Economic Commission for Europe**Inland Transport Committee****World Forum for Harmonization of Vehicle Regulations****Working Party on General Safety Provisions****127th session**

Amendments to Regulations on Gas-Fuelled Vehicles:**UN Regulation No. 110 (Compressed Natural Gas and Liquefied Natural Gas vehicles)****Proposal for Supplement 2 to the 02 Series of Amendments to
UN Regulation No. 110 (Compressed Natural Gas and
Liquefied Natural Gas vehicles)****Submitted by the expert from the European Association of Automotive
Suppliers ***

Example 2

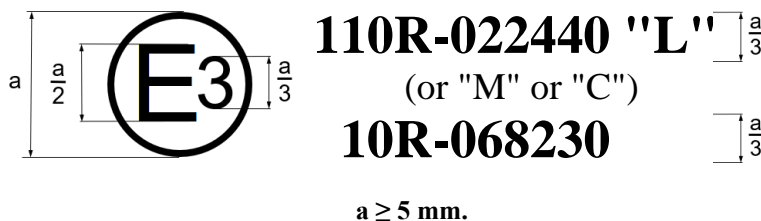
(See paragraph 7.4.3. of this Regulation)

This approval mark when affixed to the CNG and or LNG component shows that this component has been approved in Italy (E 3), pursuant to UN Regulation No. 110 under approval number 022440 and pursuant to UN Regulation No. 10 under approval number 068230. The first two digits of the first approval number indicate that the approval was granted in accordance with the requirements of UN Regulation No. 110 as amended by the 02 series of amendments.

The first two digits of the second approval number indicate that the approval was granted in accordance with the requirements of UN Regulation No. 10 as amended by the 06 series of amendments.
